The Harman Kardon Model hk570i

AM/FM/Stereo FM Solid State Receiver

Supplementary Manual

SERVICE BULLETIN #1002 - JUNE 9, 1981

TO: ALL HARMAN KARDON WARRANTY STATIONS
FROM: PETER PHILIPS, NATIONAL SERVICE MANAGER
SUBJECT: TURN ON TRANSIENT - MODEL hk5701

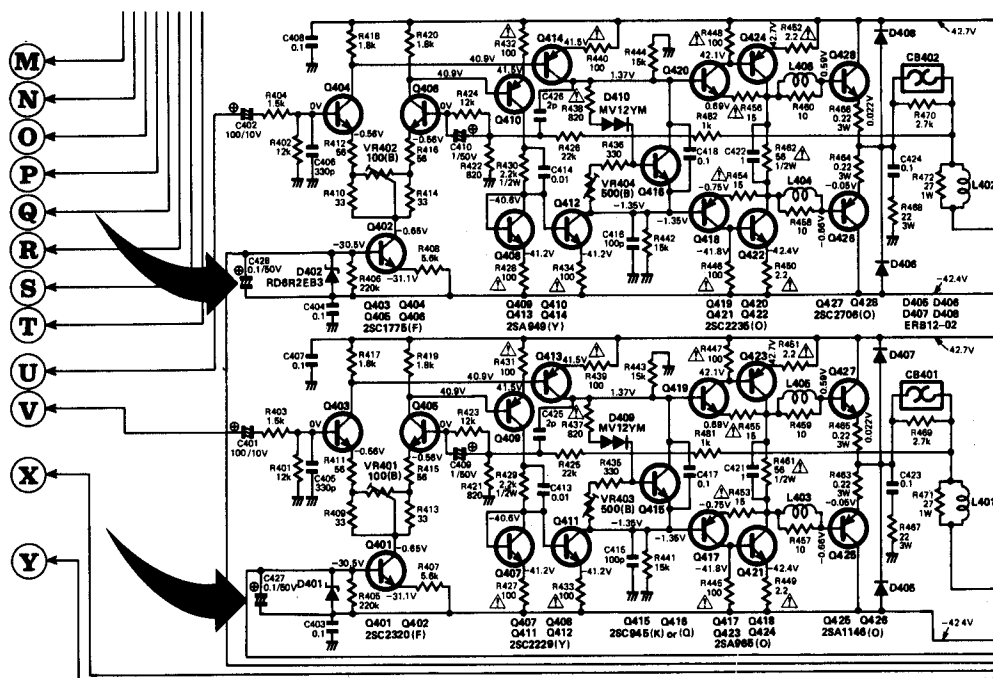
When efficient loudspeakers are connected to the hk5701, there is the possibility that a slight pop noise is heard at the moment the unit is switched ON.

In order to reduce this small "turn on transient" it is recommended to solder on the bottom of the power amplifier PC Board two capacitors across the zener diodes D401 and D402. The positive side of these capacitors shall be connected to the base of Q401 respectively Q402.

The rating of these capacitors shall be 0.1 microfarad/50V.

This modification applies only to units with serial number 08501 and lower.
